Product Change Notification

Product Change Notification: E-20-009598

COVER FOR SOCKET HOUSING, 21POS.

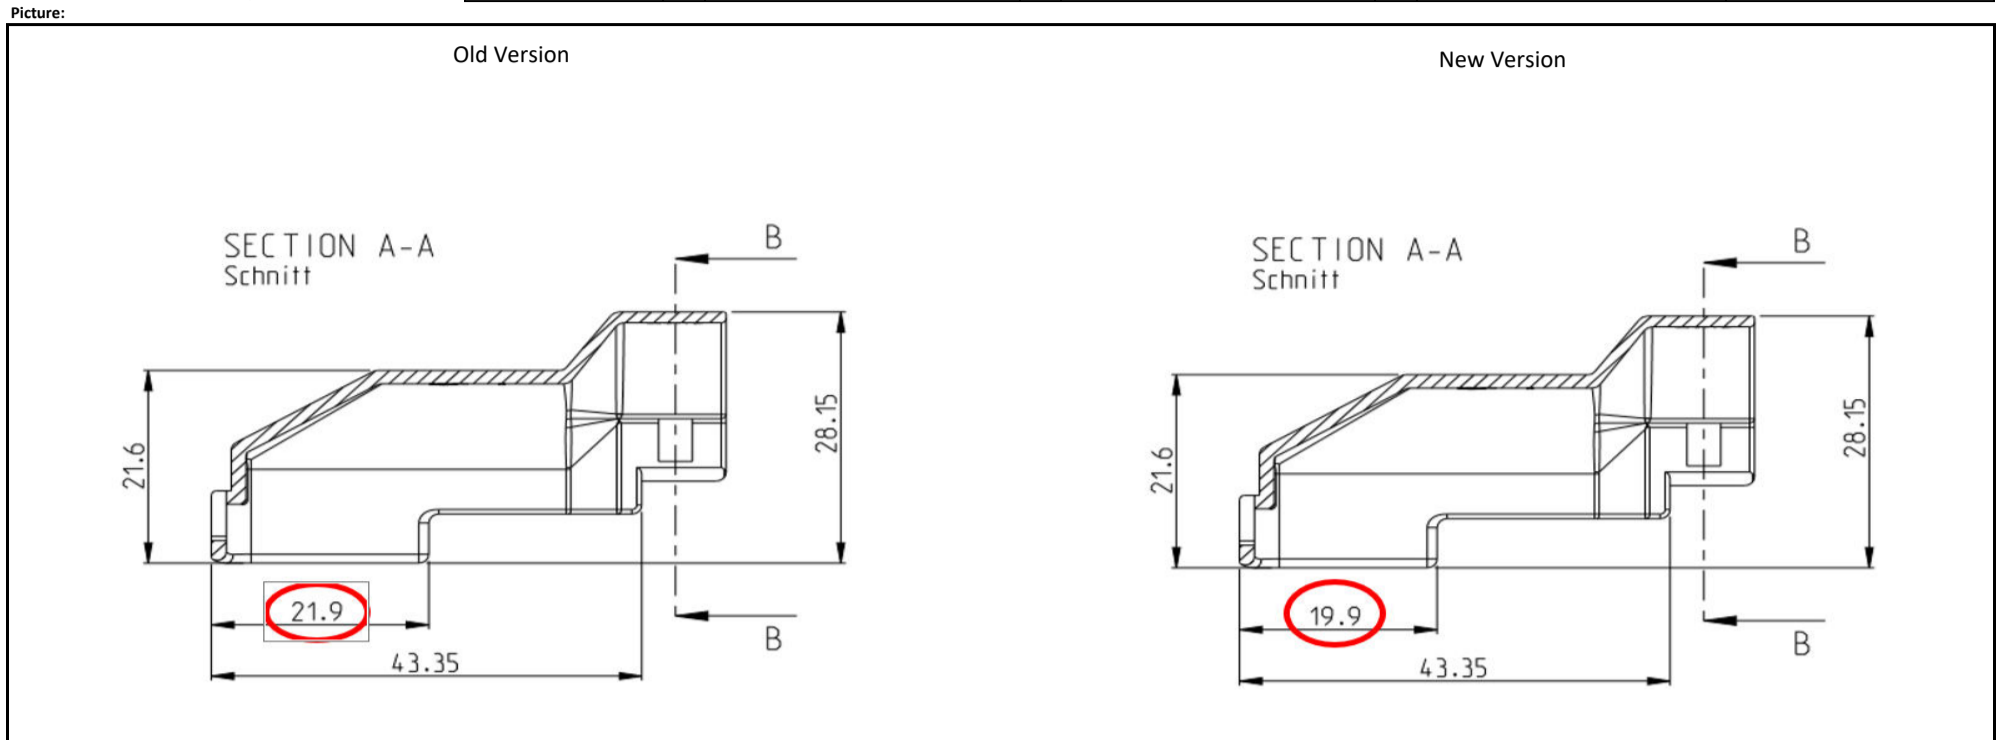
Slight change of side walls to fit cover on exiting version of 21pos Rec Hsg and new revers cable outlet version. Side wall is 2mm shorter, no change in performance. This change is considered by TE Connectivity as a Form, Fit, Function change.

<input checked="" type="checkbox"/> Potential Impact for Customer	<input checked="" type="checkbox"/> Product Type	<input checked="" type="checkbox"/> Change Type	<input checked="" type="checkbox"/> Kind of Change	<input checked="" type="checkbox"/> Change Feature	Remark / Free text
<input checked="" type="checkbox"/> No Customer Impact	<input checked="" type="checkbox"/> CAPS/COVERS AND COVER ASSEMBLIES	<input checked="" type="checkbox"/> Form, Fit, Function	<input checked="" type="checkbox"/> Geometry	<input checked="" type="checkbox"/> Special Design Feature	Slight change on cover side walls to fit cover on a second version of 21pos Rec. Housing. No change in protection performance.
